Certificate of Appropriateness

Milwaukee Historic Preservation Commission/841 N Broadway/Milwaukee, WI 53202/phone 414-286-5712

2105 E Lafayette PI North Point South

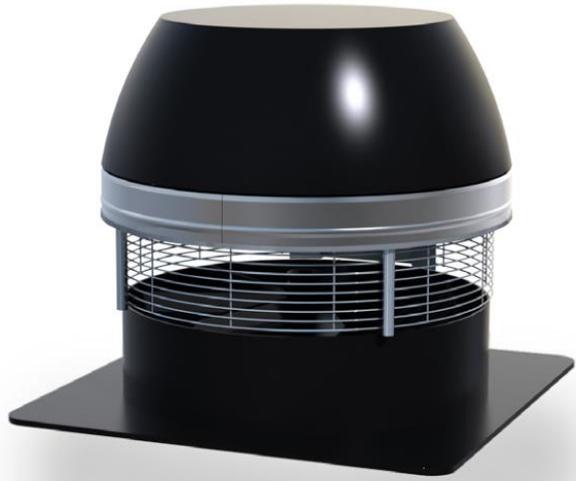
Affected chimneys circled in orange.

Left: Typical vent fan to be used for single flue on east chimney. Must be covered by a square, traditional spark arrestor/flue cover.

Below: Sample copper caps. Owner may choose to cover affected flues or all flues.

Install chimney caps on two primary chimneys. Install powered vent fan on east chimney. Vent fan **MUST** be covered by a copper or black flue cap to minimize its appearance. Wiring must be placed on north face of chimney and fully encased in conduit that is painted to match surrounding building material.
